# Groundwater Transfer Review Summary Form

Transfer/PA # T- 13524 (J.R. Simplot: J.R.S. Properties III, LLP)

GW Reviewer Gerald H. Grondin

Date Review Completed: 24 November 2020

LAKE 1719

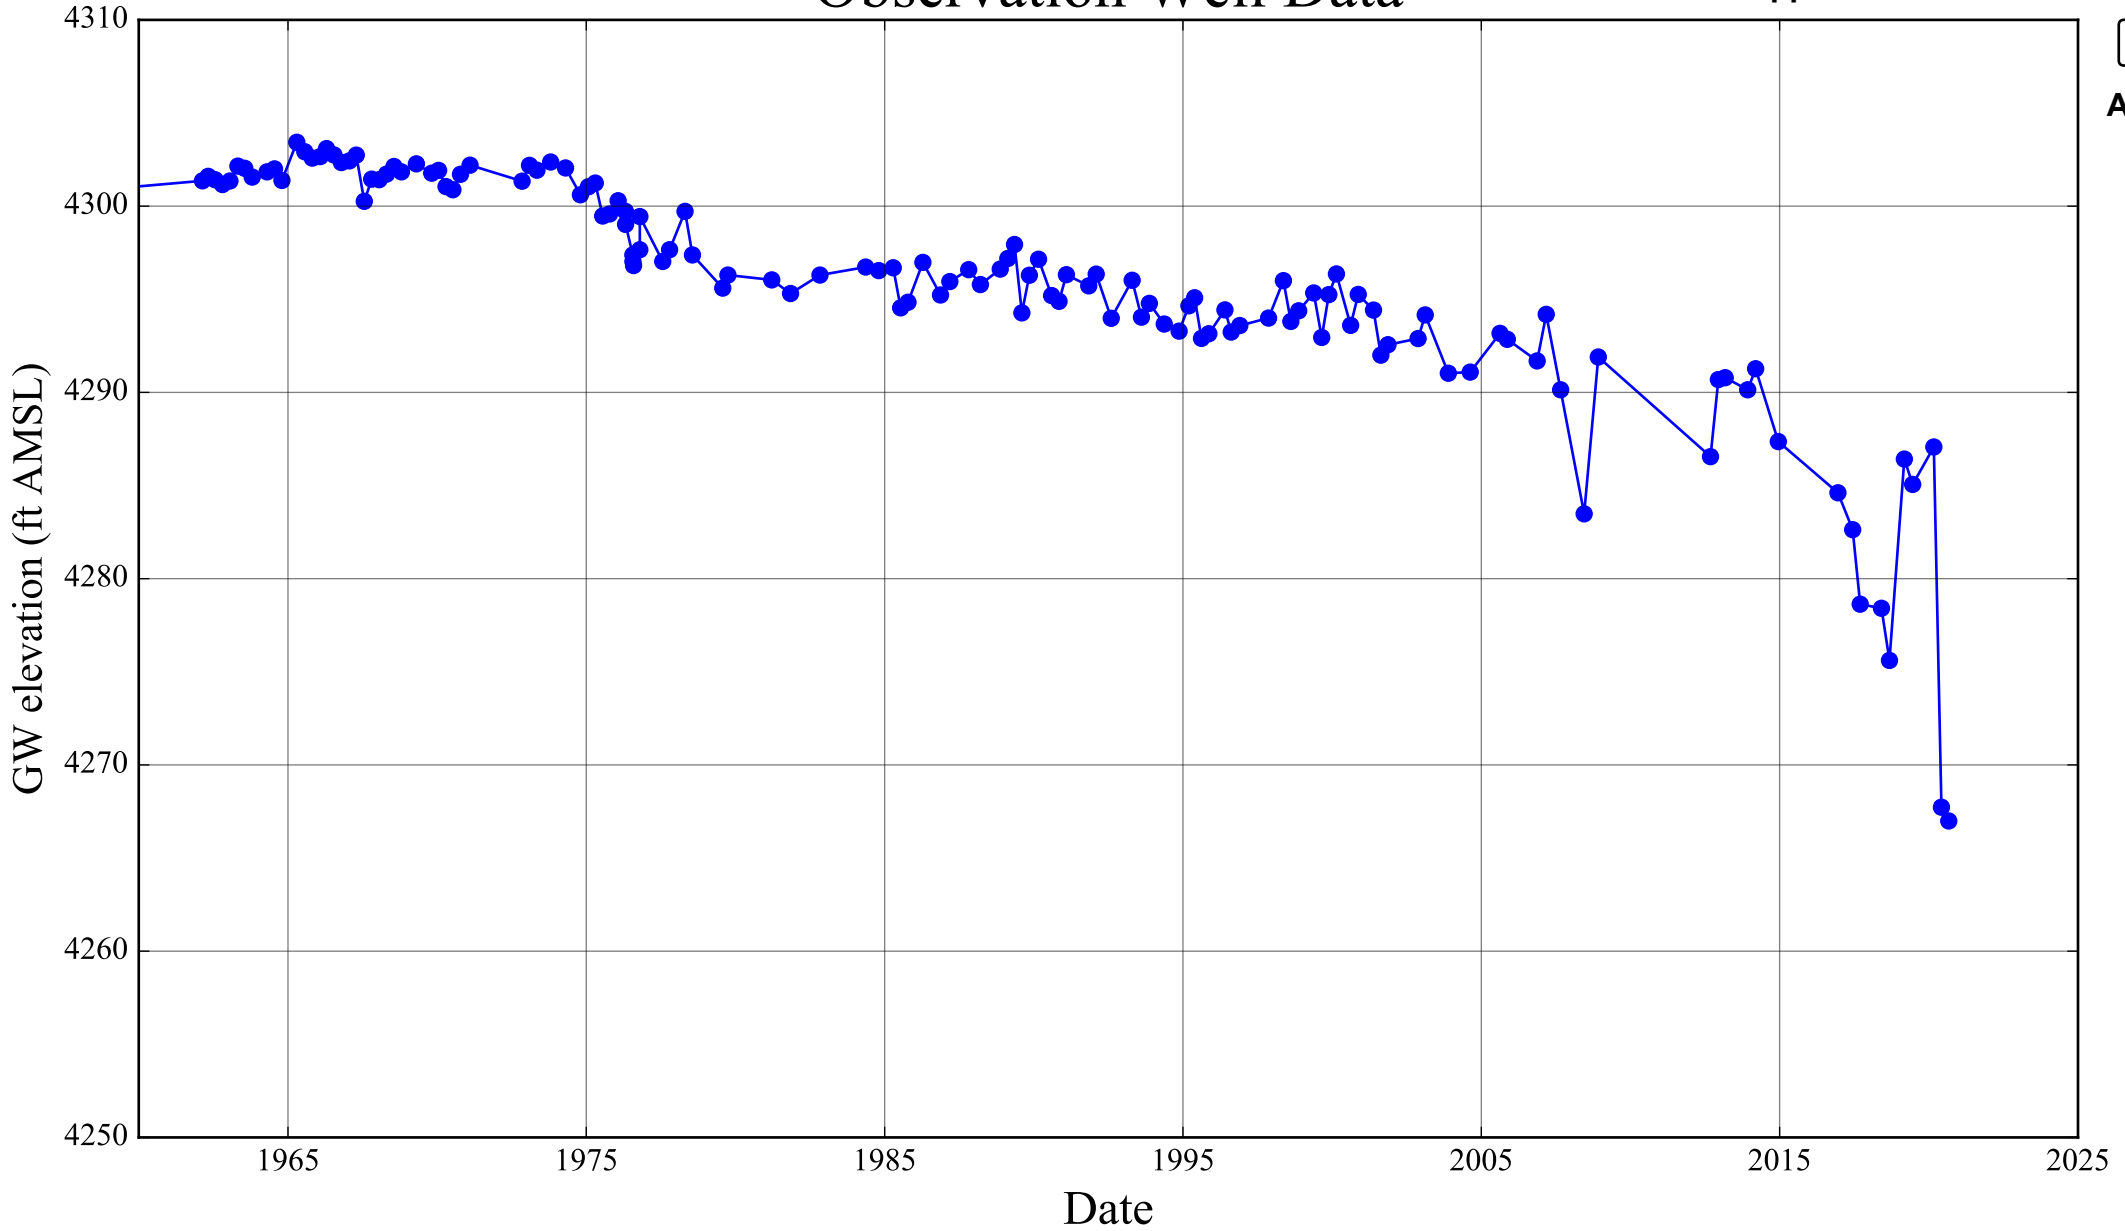
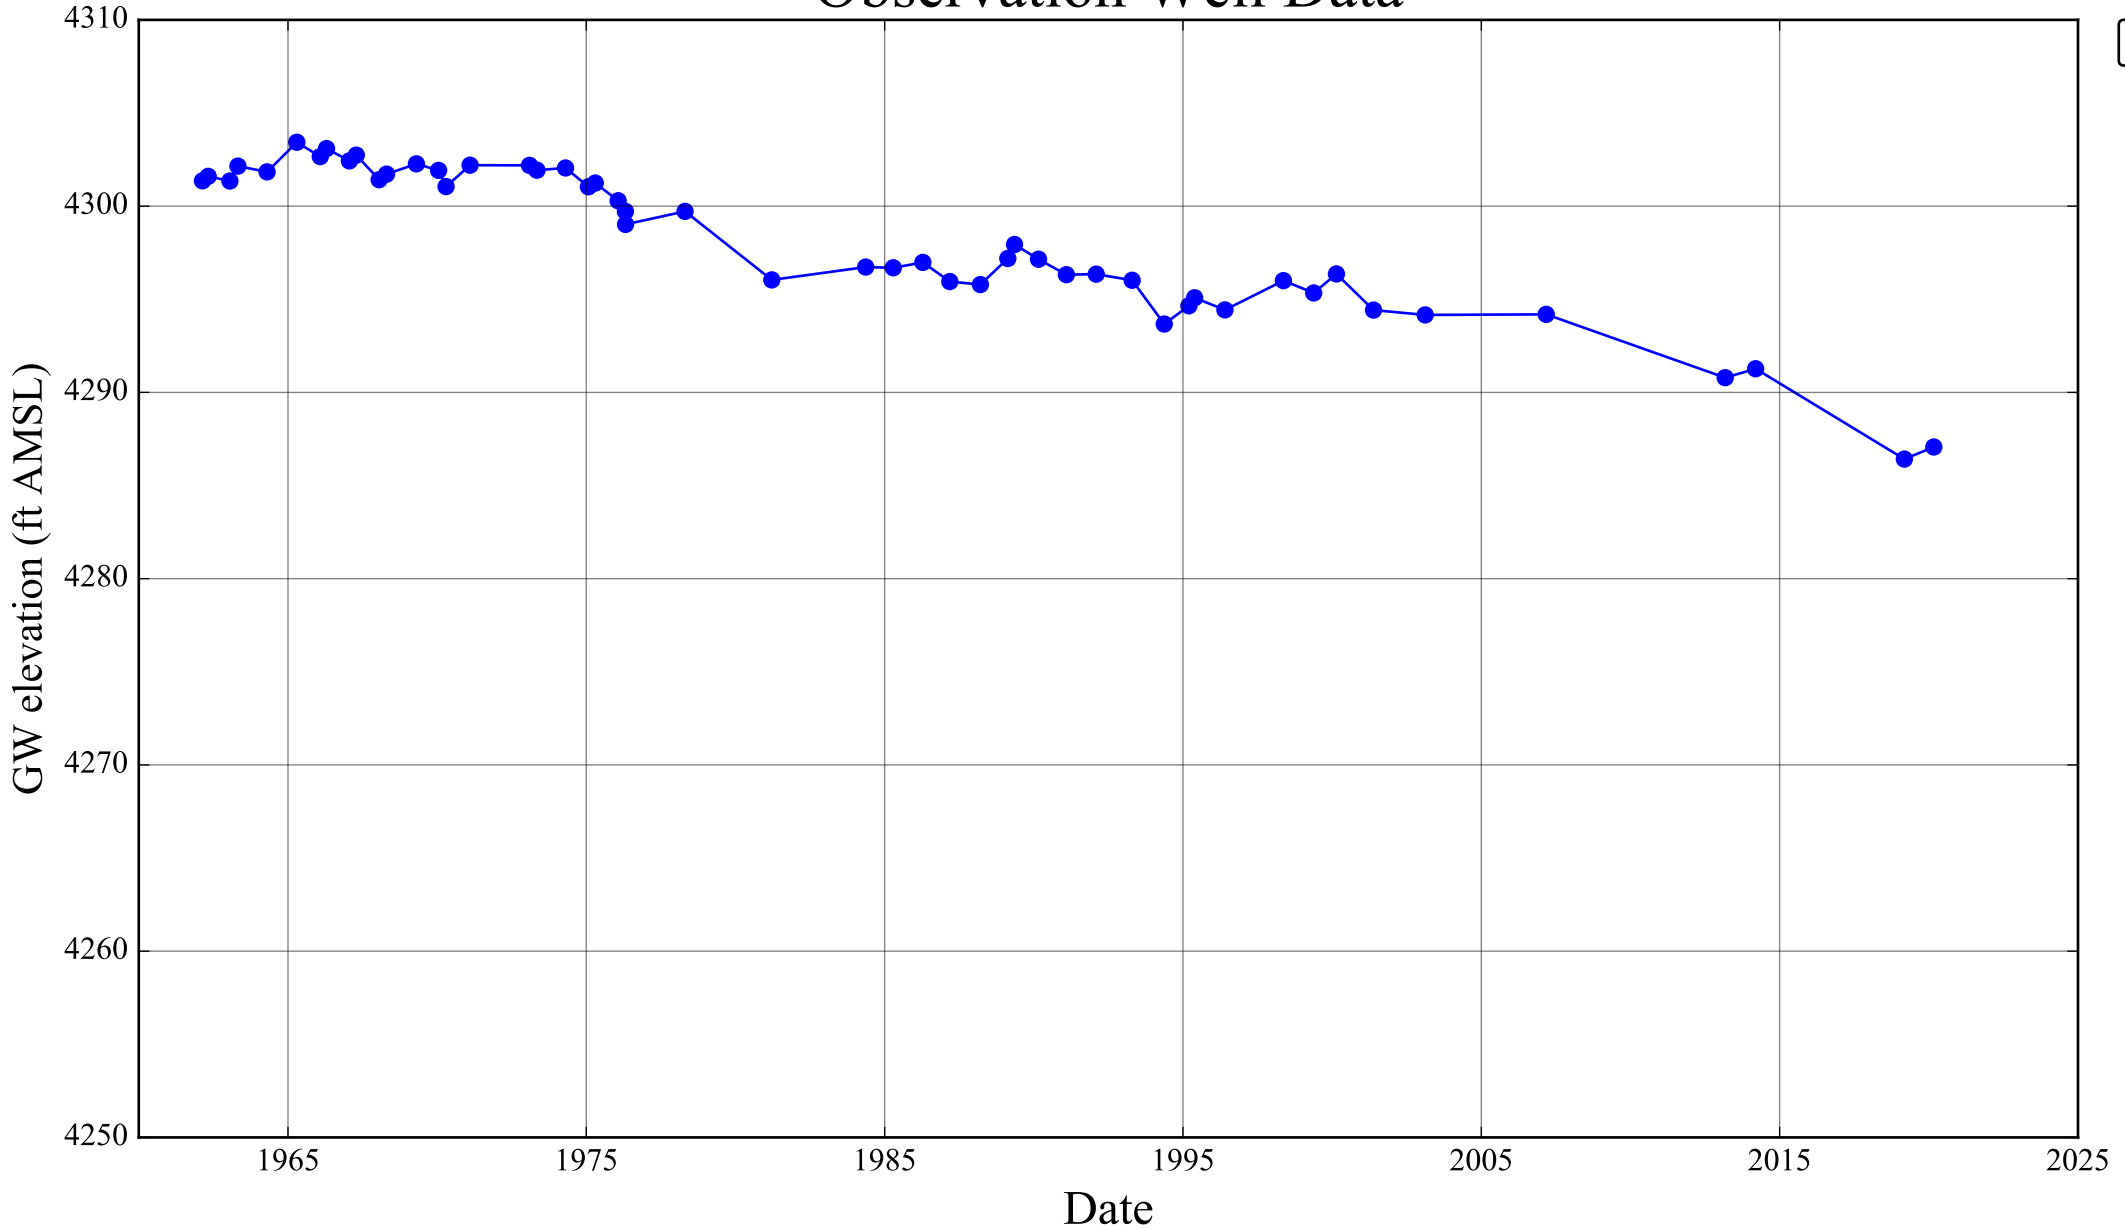
Additionally, the proposed change moves groundwater pumping into a vicinity that may be experiencing a groundwater level decline since 2005 (see attached hydrographs for well LAKE 1719 [417-feet total depth]: data from all seasons and data from winter-spring only). The hydrograph for well LAKE 1719 showing data from winter-spring only shows relatively stable groundwater levels near 4302 feet elevation amsl from 1960 to the mid-1970s, a decline of about 5.5 feet from the mid-1970s to early 1980s to a new equilibrium of about 4297 feet elevation amsl that is close to the Chewaucan River stage near the Narrows (relatively steady from about 1980 to 2005), and an ongoing decline since 2005 of about 0.58 feet per year, possibly taking the groundwater level below the river bottom. The groundwater level decline in the 1970s and after 2010 appears to correspond to increased groundwater development in the area.

- LAKE 52769
- LAKE 52770

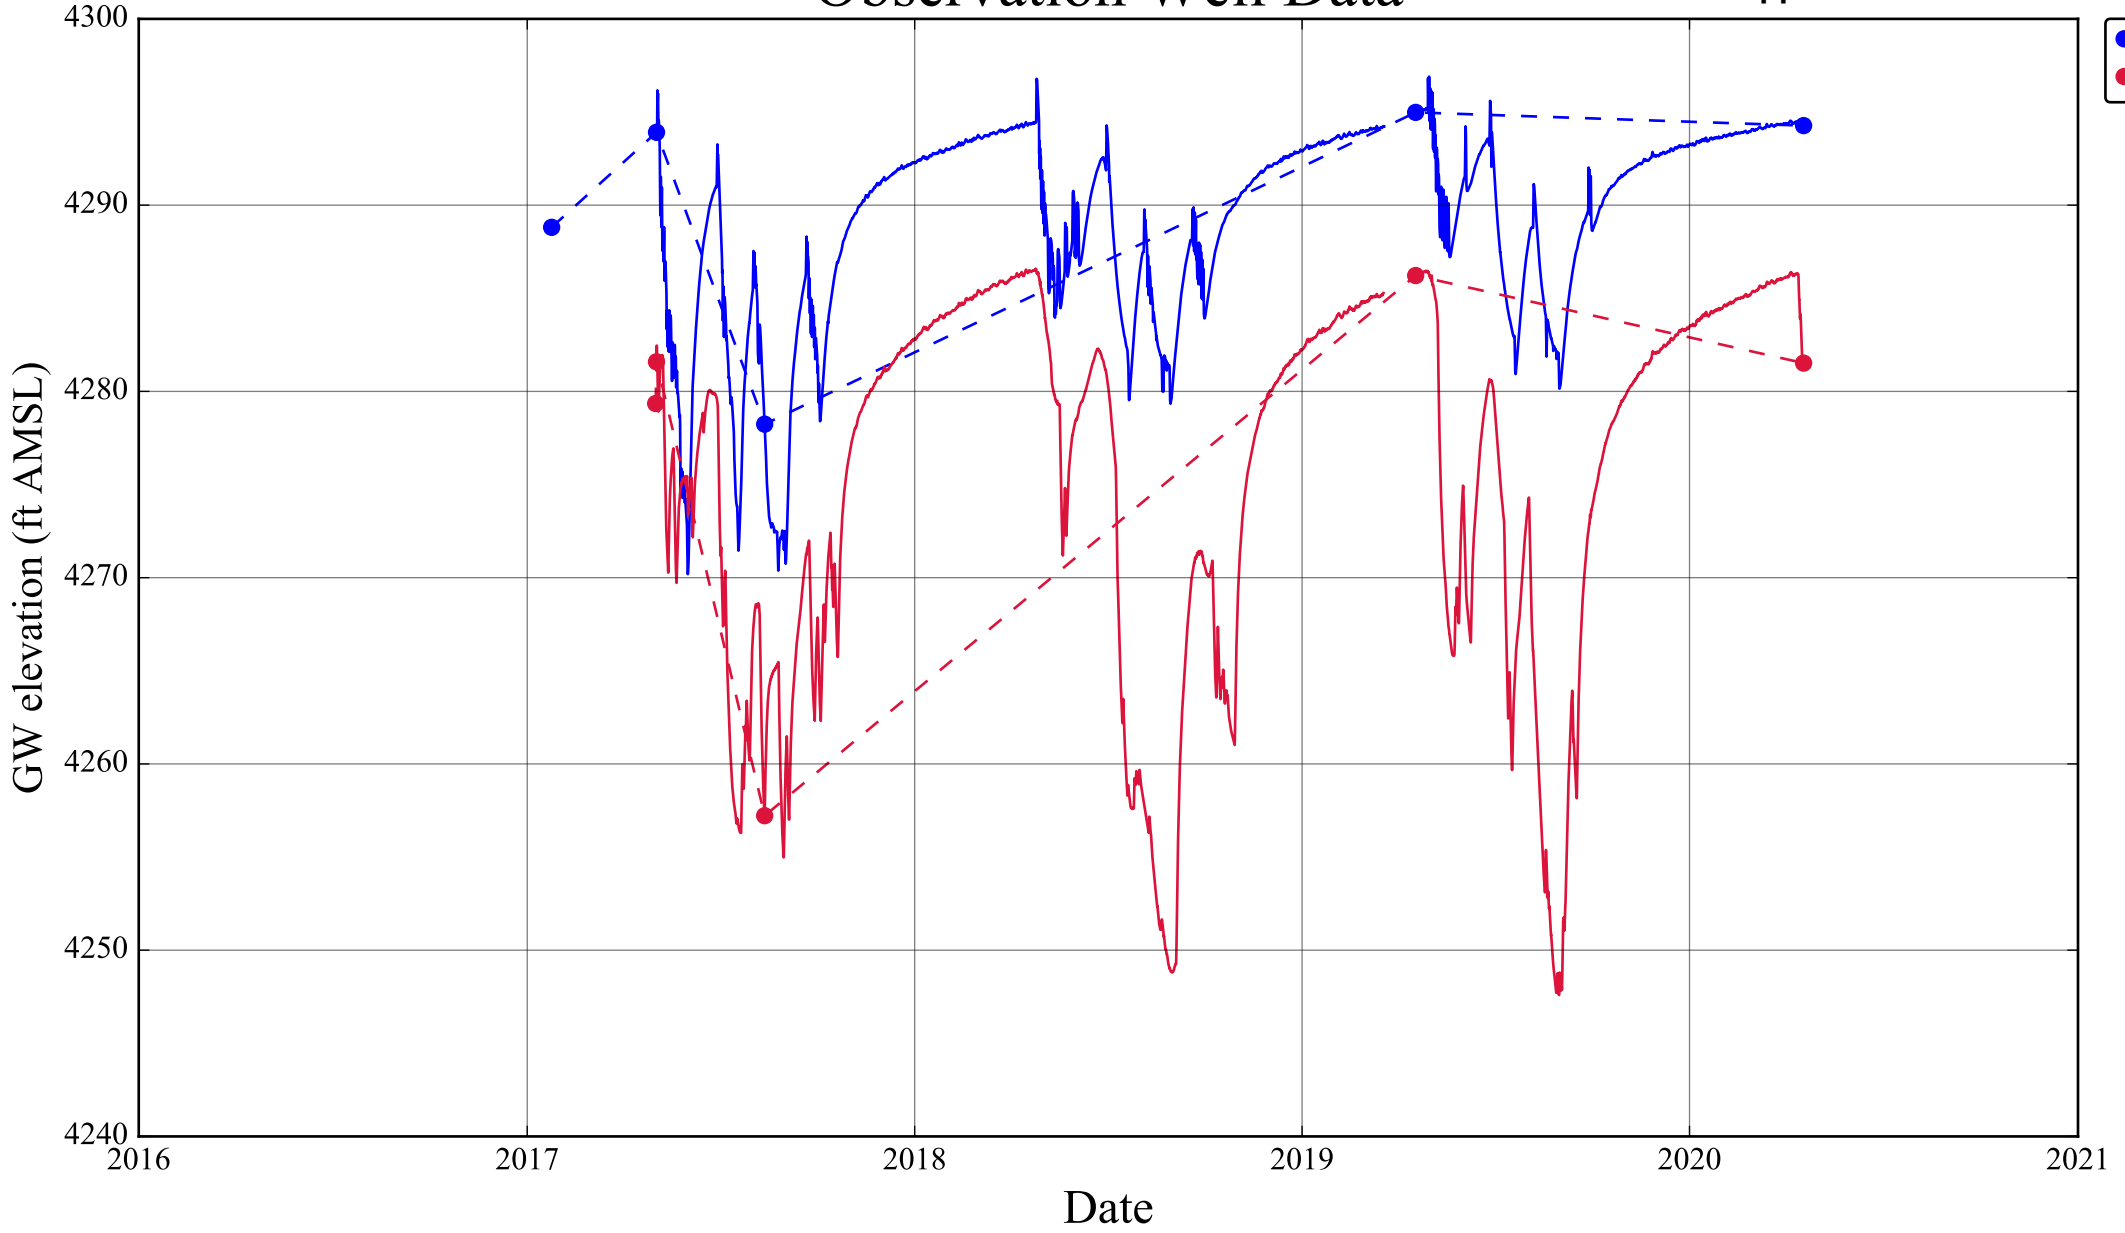
Conversely, the applicant has submitted 2017 to 2020 data (see hydrographs for wells LAKE 52769 [60 feet total depth] and LAKE 52770 [1,100 feet total depth]) showing no to little decline during that period. The data can be interpreted as showing 0.00 to 0.25 feet per year decline.
